PERMIT

SEWAGE DISPOSAL SYSTEM

MARYLAND STATE DEPARTMENT OF HEALTH

SUBDIVISION _____ ROAD 1669 Henryton Road LOT Parcel 3

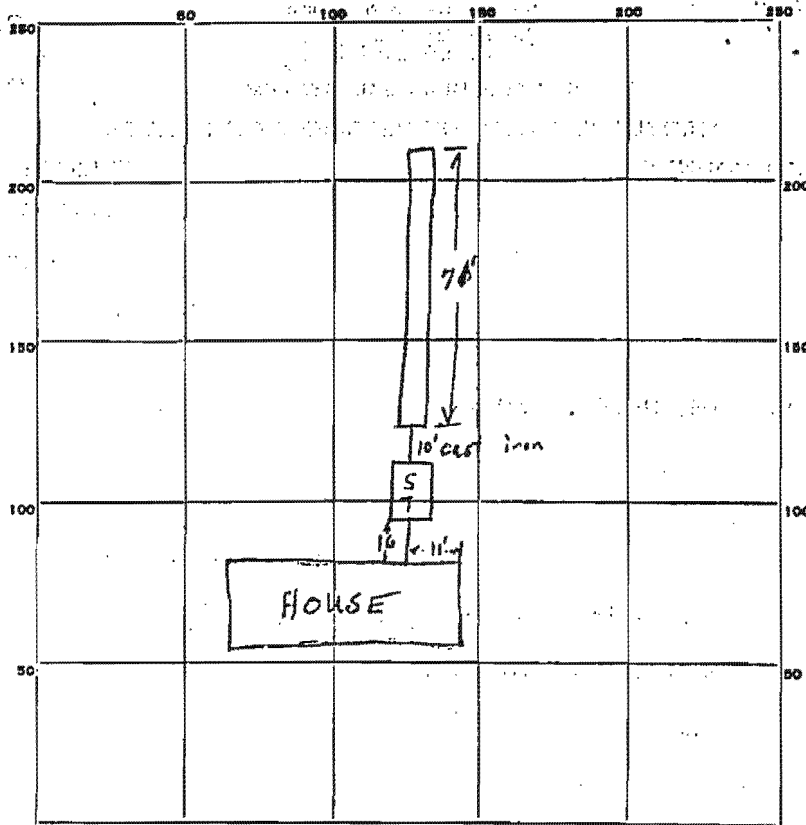
REMARKS 7/2/75 Location not as specified, Trench is down slope,
but much closer to house than originally called for.
Soil is good, and should have adequate repair area.

NO impact noted
OK/SM

OTHER TRENCH - 500 sq. ft. trench - one side - Maximum depth 10 ft. Inlet to be 3 ft. below original grade. Locate 150 ft. from back property line and 10 ft. from left property line as seen when facing lot from right-of-way. Septic tank must have manhole type cleanout to grade level. Call for inspection of trench before gravel is installed.
